Kaixi Lingerie Bangladesh Co Ltd

Plot# 183-188 and 189A-193, BEPZA Economic Zone -01, Mirsharai, Chattogram.

21 April 2025

Observation 02: Discrepancies in the as-built drawings (Main Production Building)

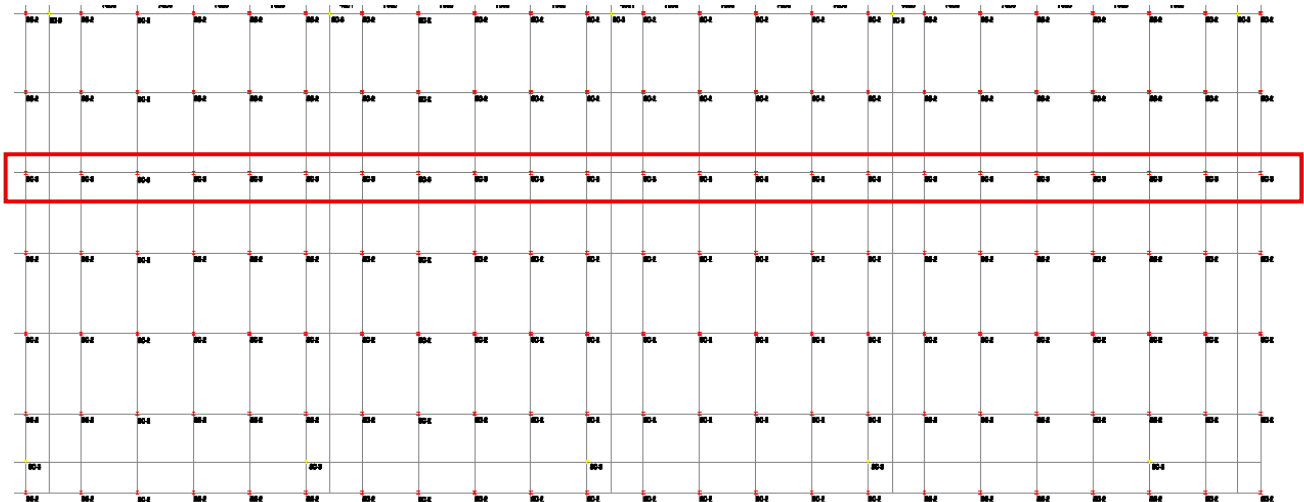
Description: At grid F (highlighted in red in the image above), the drawings specified SC3 columns (Web 300×10, Flange 300×16) from the 1st to 3rd floor; however, SC2 columns (Web 350×10, Flange 350×16) were found in place.

3.		Carry out suggested remedial works if required	within 6 months
4.	Discrepancies in the as-built drawings (Main Production Building)	The building engineer is required to survey the whole structure and prepare accurate as-built drawings as per onsite conditions.	within 6 weeks

Observation 03: Cut of flange in steel column & beams (Main Production Building)

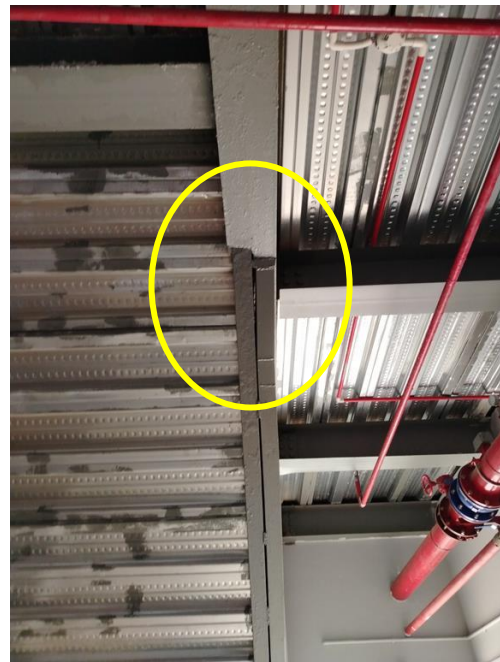
Cut off the flange in the steel column

Cut out the flange in the steel beam

Description: Flanges were cut in several beams and columns, potentially compromising their structural integrity.

5.	Cut off flange in steel column & beams (Main Production Building)	The building engineer is required to repair the cut portion with a suitable method or check the adequacy of the member for the net area of the flange.	within 6 weeks

Observation 06: Dampness on brick wall (Main Production Building)

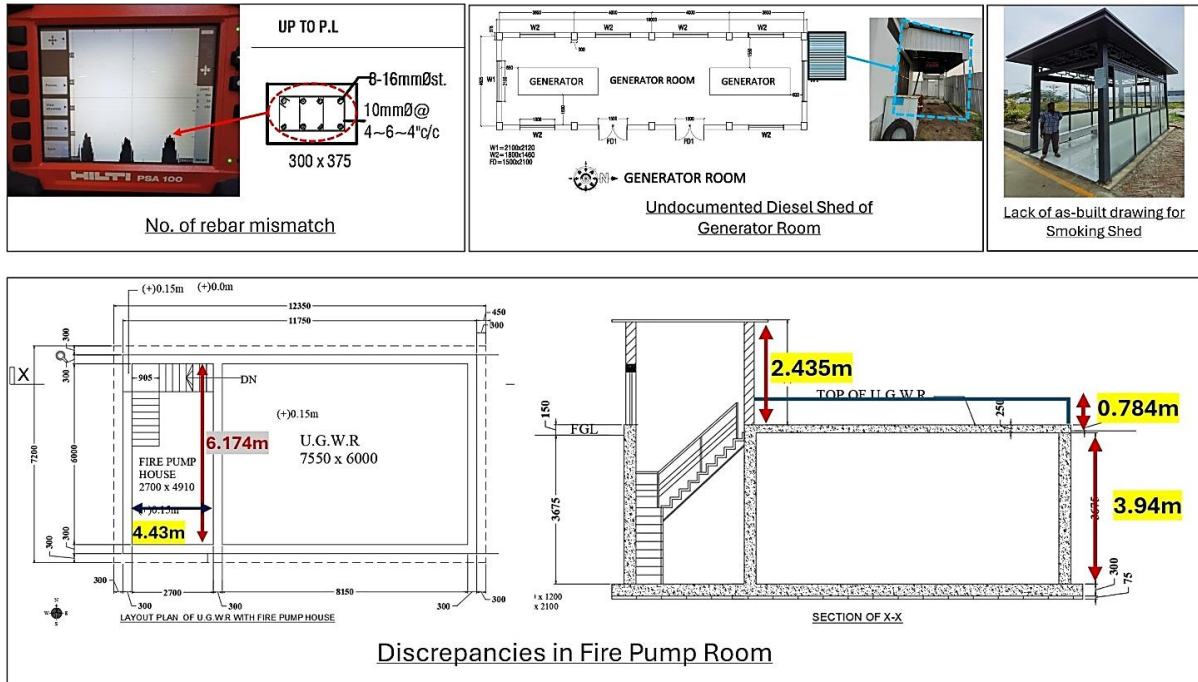
Description: Dampness was found on the masonry wall in the toilet area.

8.	Dampness on the brick wall (Main Production Building)	The factory is required to repair the dampness with suitable measures.	within 6 weeks
9.	Discrepancies in the as-built drawings of all the ancillary structures.	The building engineer is required to survey the all structure, prepare accurate as-built drawings as per onsite conditions and submit to RSC for review.	within 6 weeks
